**DATE:** October 11, 2019, *Revised April 24, 2020*

**FROM:** Corky Poster, Architect/Planner, Design Professional

**RE:** Hotel Congress, 311 East Congress Street, Tucson AZ  
**DP 19-0190**

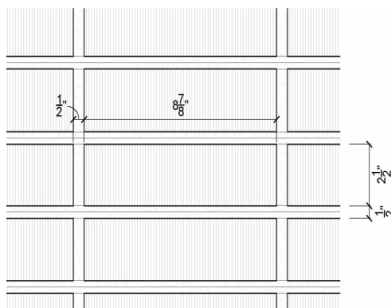
**1. Perhaps use same brick but with stack-bond on the bathroom to avoid historic imitation.**

BRICK DIMENSIONS & MATCHING MORTAR JOINTS STACK BOND AT NEW WORK – DIFFERENTIATED FROM EXISTING HOTEL CONGRESS RUNNING BOND

*The project proposes to use a stack-bond as suggested. Thank you.*
